Interactive comment on "Towards verifying  $CH_4$  emissions from hard coal mines using mobile sun-viewing Fourier transform spectrometry" by Andreas Luther et al.

Dear Anonymous Referee #1,

Figure 1: A-priori versus retrieved  $CH_4$  profile. Note, that the retrieval only scales the lower part of the a-priori profile up to the the expected maximum PBL-height of roughly 800 hPa (1700 m above ground). The gray line represents an intra plume measurement.

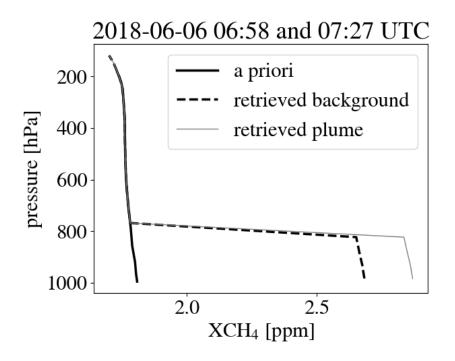
S13: p5115 - Is this the first study to scale only the lower part of the a priori profile for EM27/SUN retrievals? Also, some examples of a priori and a posteriori profiles in e.g., the supplement would be helpful.

Butz et al. (2017) scaled the lower tropospheric part of the vertical profile only as they expected the plume of the volcano Etna to be homogeneously distributed in a certain layer between 3.2 and 4.9 km. This is somewhat similar to our cases as we expect the plume to be homogeneously distributed inside the PBL. We added a  $CH_4$  profile example figure in the supplement (Figure 1).
